Permit Number HS002337

Onsite Wastewater Treatment System Permit Application

Address* 10691 Old Cheney Rd City Lincoln, NE Zip 68526
(no rural route)

From: Terri Jakoubek <jakoubek63@windstream.net>
Sent: Tuesday, July 5, 2022 6:07 PM
To: Nate C. Hartman
Subject: HS002337 Revised Permit
Attachments: HS002337 Revised.pdf

Onsite Wastewater Treatment System
Preliminary Plan Specification

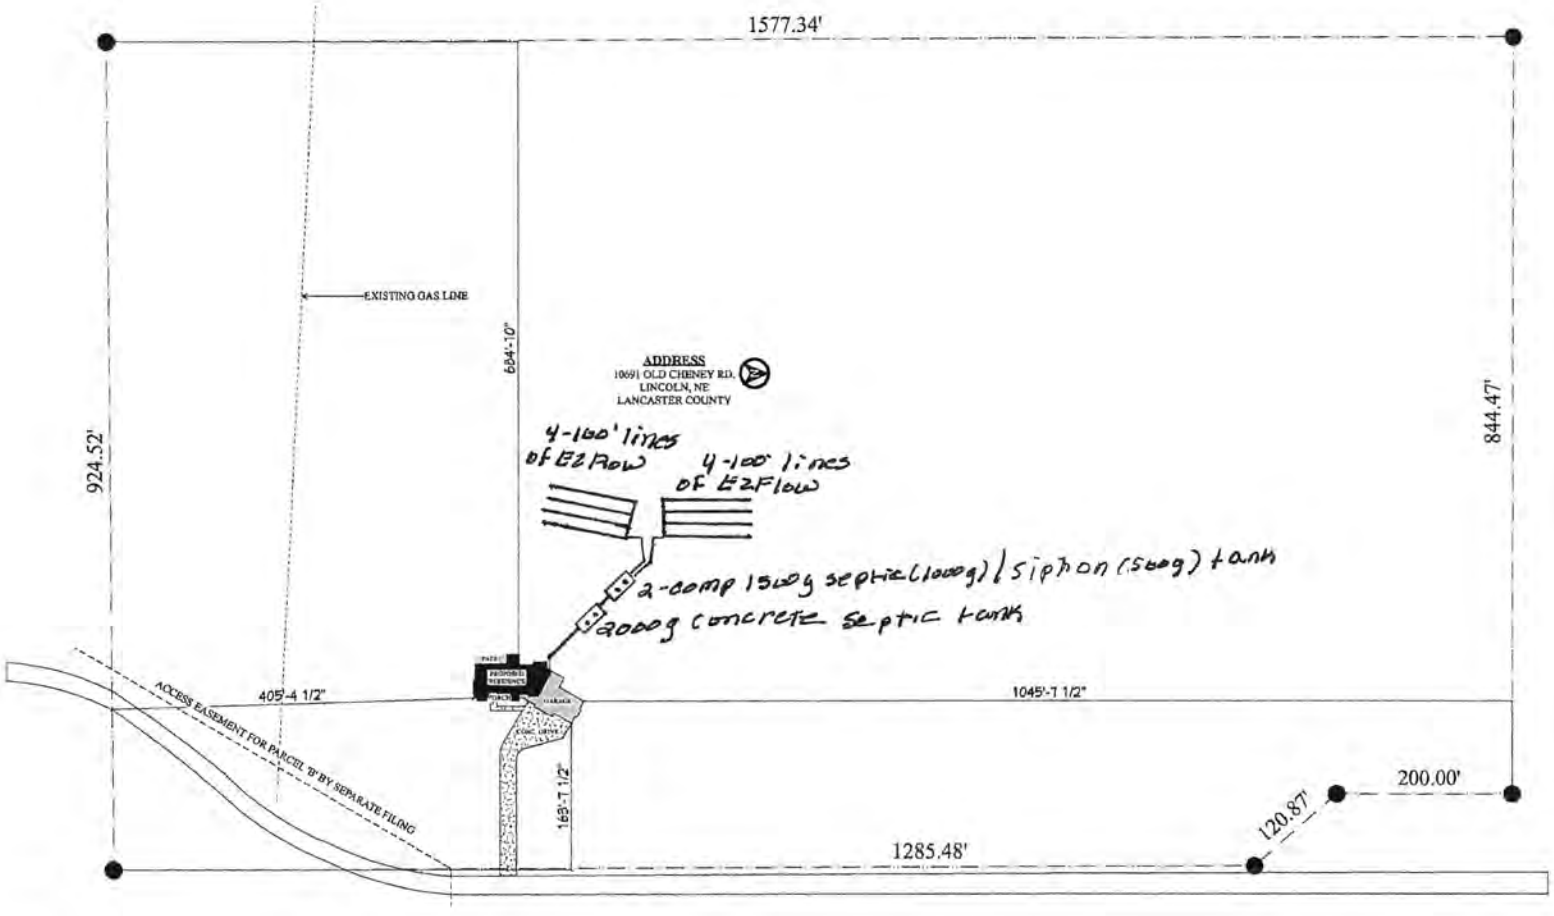
Hi Nate, I've attached revised paperwork for the Dallmann property @ 10691 Old Cheney Rd (Denny Van Horn-Builder). I know Vern spoke with you about his one (we have a siphon installed in the 500g portion of the 1500g 2 compartment tank for the 800' of EZFlow). Hoping to get it installed this week. We have the drainfield oversized a bit. Let me know if you have questions.

B. Proposed Septic Tank/s (2000g + 1500g 2 compartment)

Septic Tank Cap. 3000 gals + 500g syphon tank Tank Material: ☑ Concrete ☐ Plastic ☐ Other _____ ☐ Lagoon (Max. Seepage 1/8"/day)

Percolation Rate 60 (min/inch = mpi) No. of Bedrooms 8 Soil Type Judson SL/Aksarben SCL Land Slope _____ %

☑ Trench ☐ Bed ☐ Non-standard (engineer-designed and NDEQ approved) Total square feet of drainfield 3600 Sq. Ft.

Total length of laterals 800' Type of Distribution: ☐ Perforated Pipe ☐ Half-Round ☐ Chambers ☑ Other EZFlow 1203H

No. of Absorption Trenches 8 Width 38" No. of Drop Boxes 1 Distribution Box _____
